BR2LDU1L0200	G	Cover Page	19/06/2019
BR2LDU1L0201	G	Concept Plan	19/06/2019
BR2LDU1L0202	H	Landscape Sections	19/06/2019
BR2LDS1L0201	A	Modifications summary	19/06/2019

These drawings supersed the follow drawings list:

Original approved plan

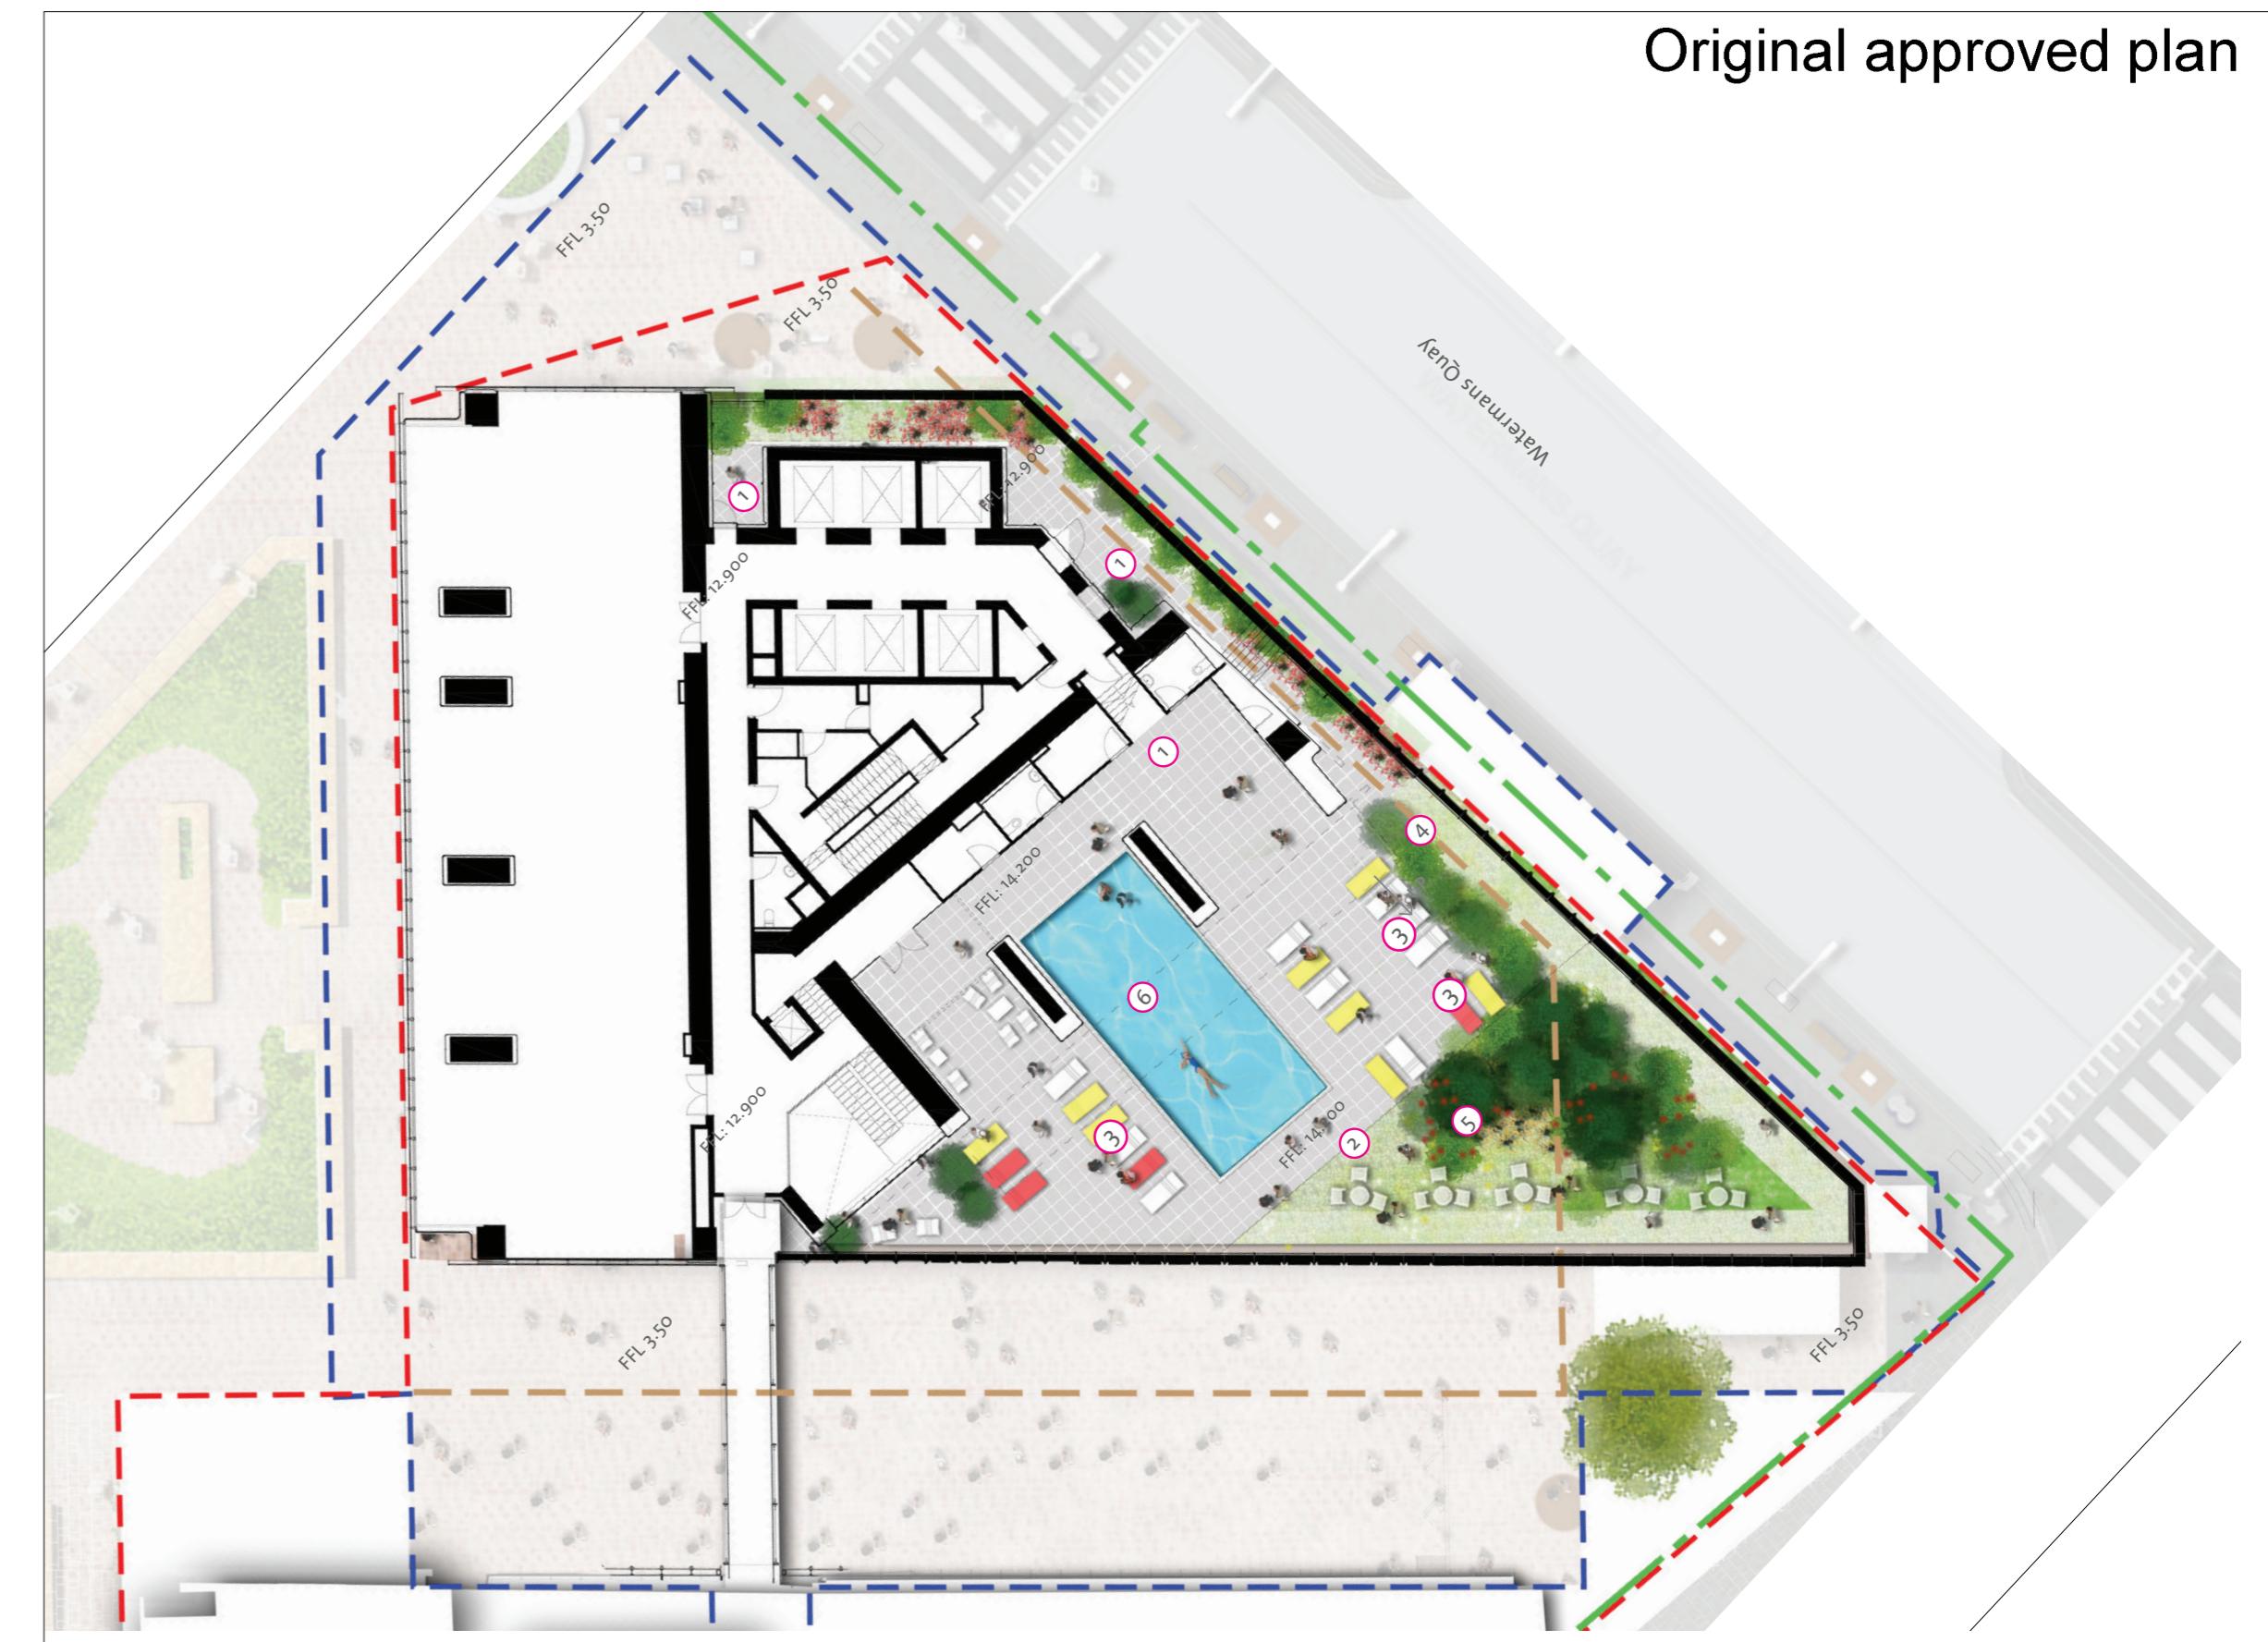
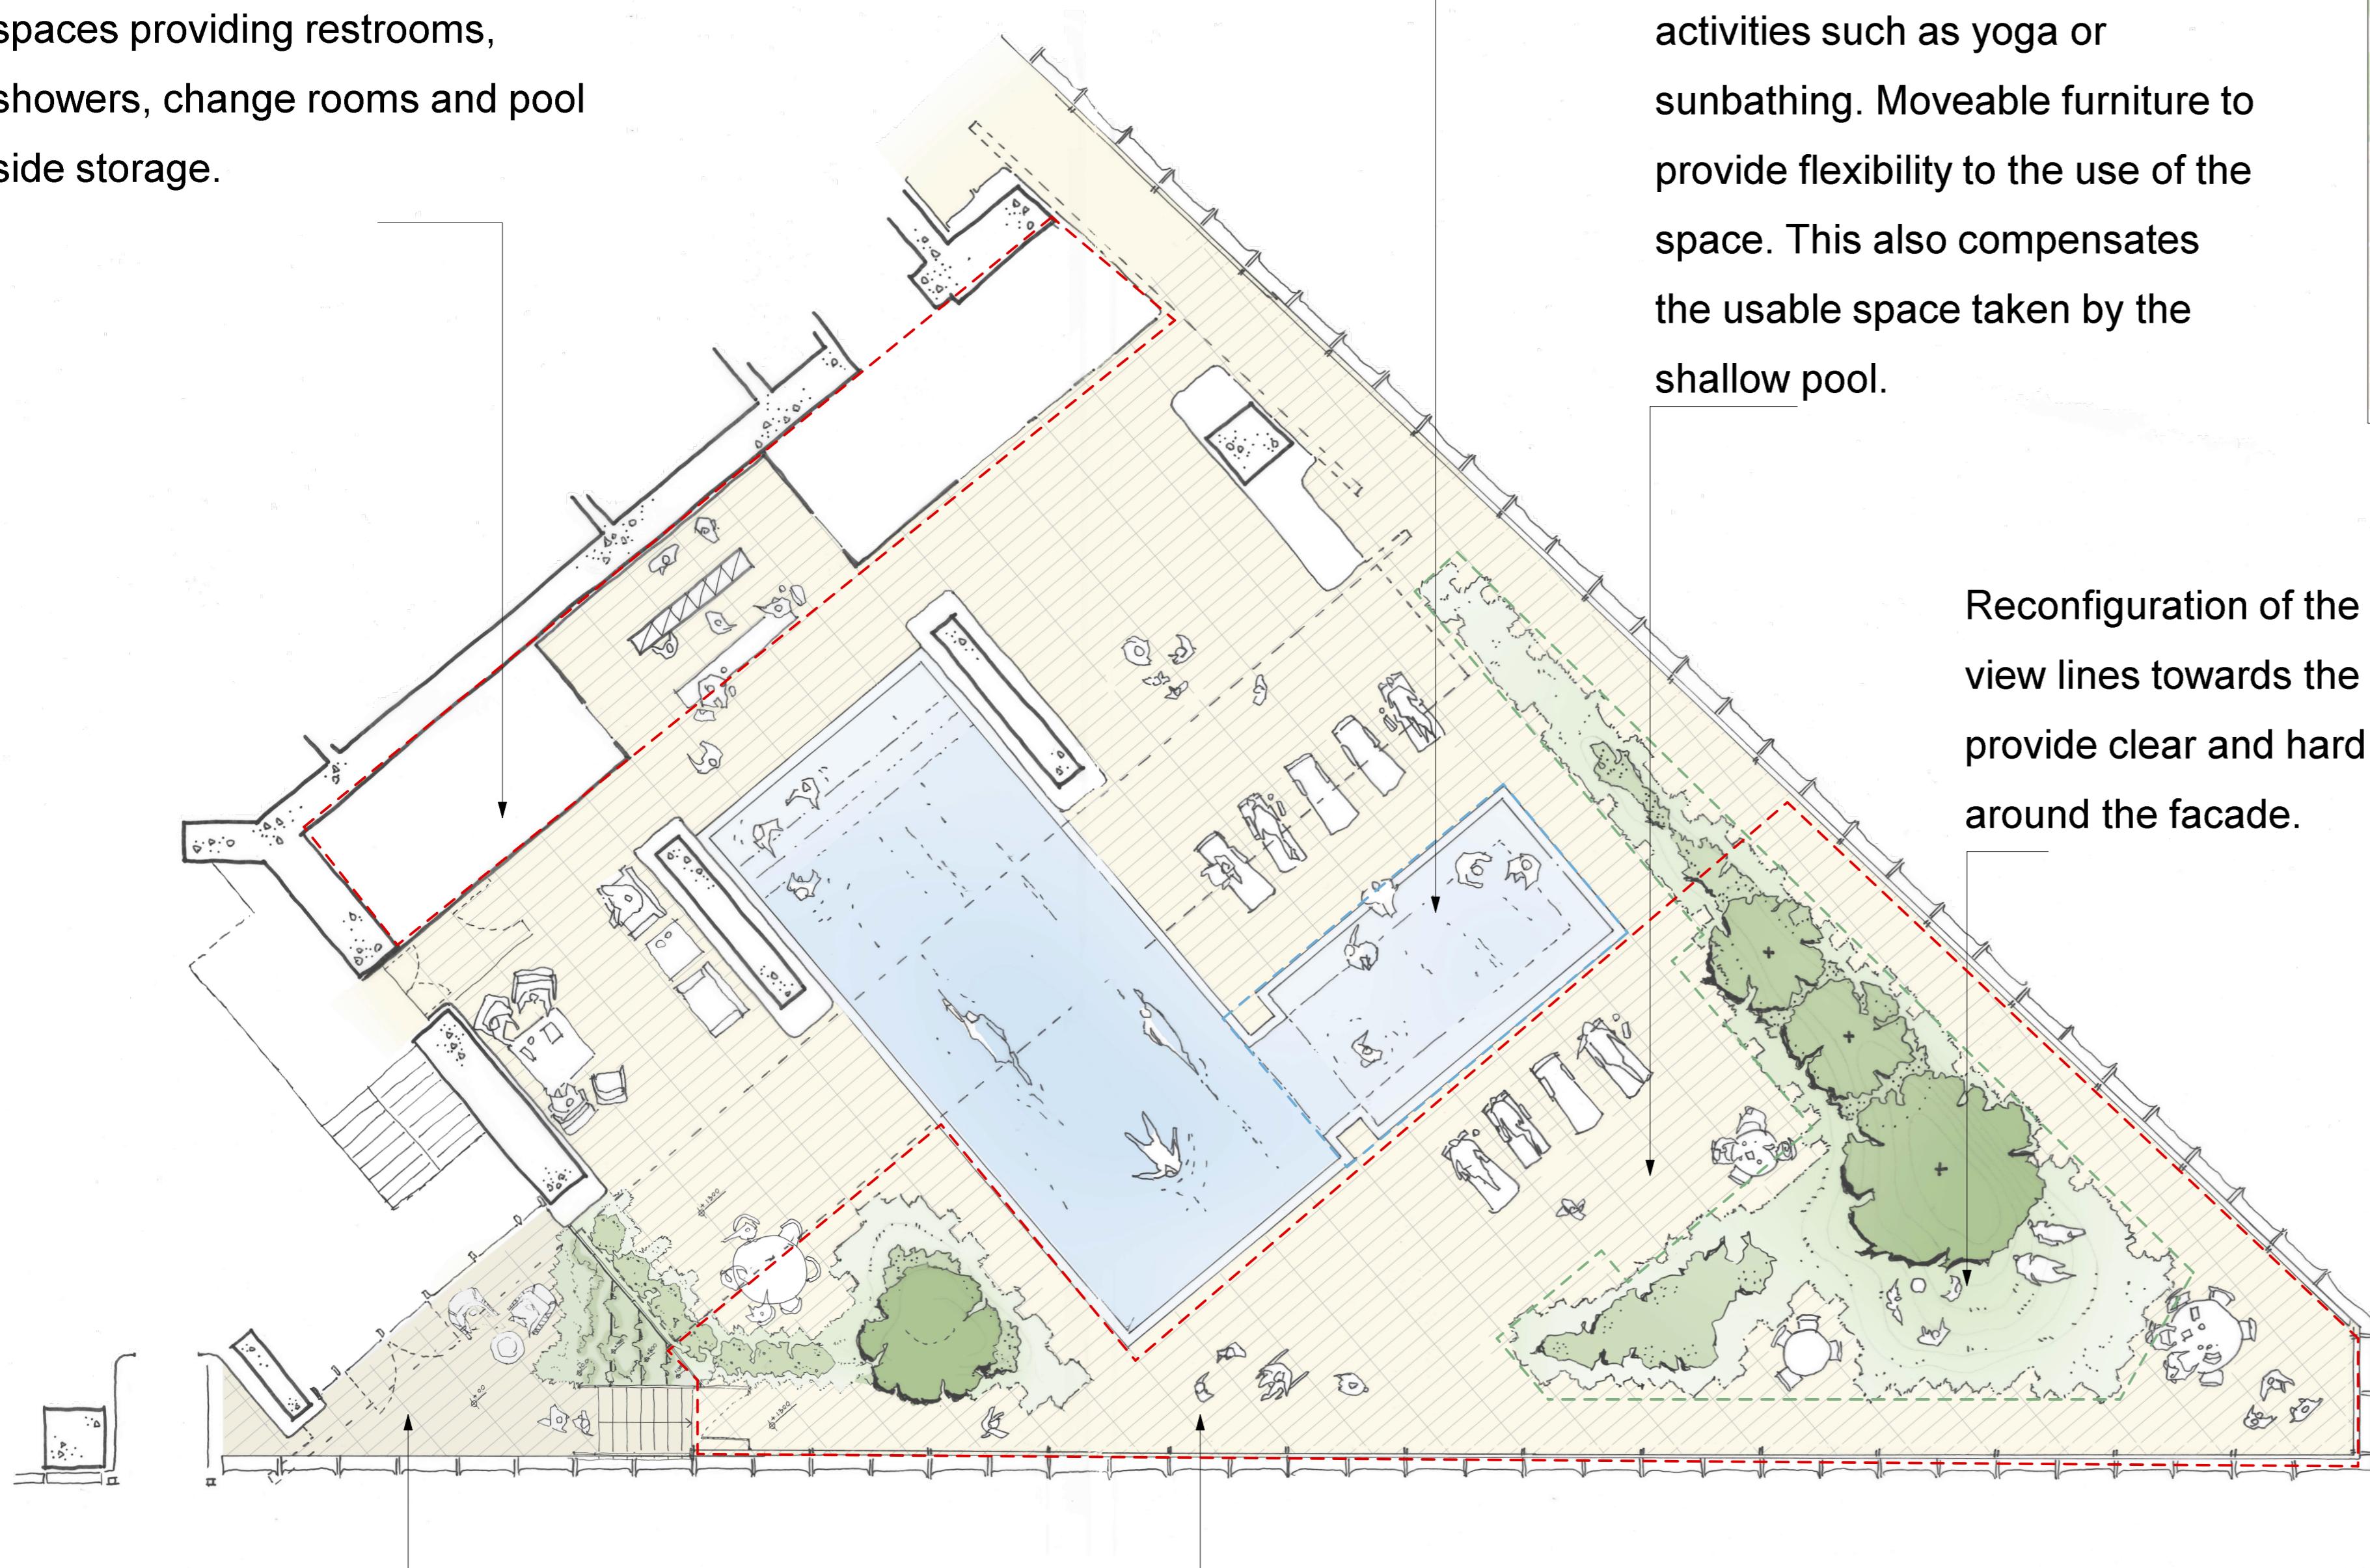
Reconfiguration of amenity spaces providing restrooms, showers, change rooms and pool side storage.

Addition of a shallow pool to cater other water uses for both children and adults.

Increase in the usable space at the front of the pool for various activities such as yoga or sunbathing. Moveable furniture to provide flexibility to the use of the space. This also compensates the usable space taken by the shallow pool.

Reconfiguration of the planting area to improve the view lines towards the harbour from the pool and provide clear and hard paving maintenance access around the facade.

Changes to the entry level with the arrival to the pool area from the corridor of the internal common amenities.
